ADDENDUM No. THREE

Project Name:	Campground Improvements Cape Henlopen State Park
Project No.:	CH-44
Contract No.:	2015-CH-300
Date of Issue:	July 20, 2015
Notice No. 1:	Attach this addendum to the Project Manual for this project. It modifies and becomes part of the Bidding Documents. Work or material not specifically mentioned herein is to be as described in the main body of the specification and as shown on the drawings.
Bids Due:	Tuesday, August 2, 2016 at 2:00 PM Auditorium DNREC, Division of Parks and Recreation 89 Kings Highway, Dover DE 19901

TYPICAL TRANSFORMER LOOP-FEED INSTALLATION DETAIL

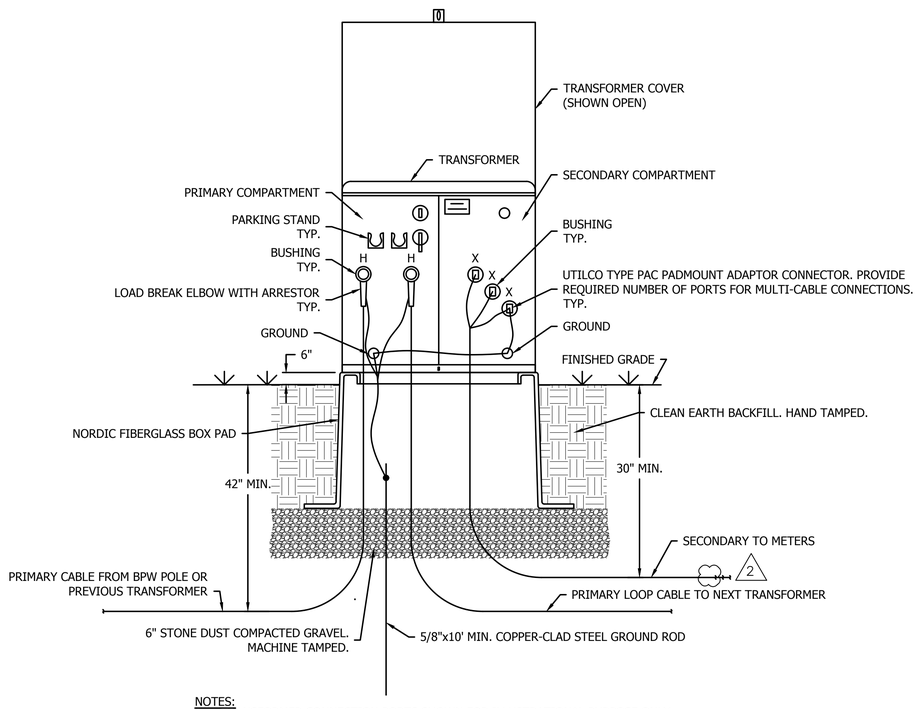
10 Sheet E4.2 Electrical Details: Detail Typical Transformer Loop-Feed Installation Detail has been revised at the secondary to meters. This sheet has been revised and is included with this Addendum.
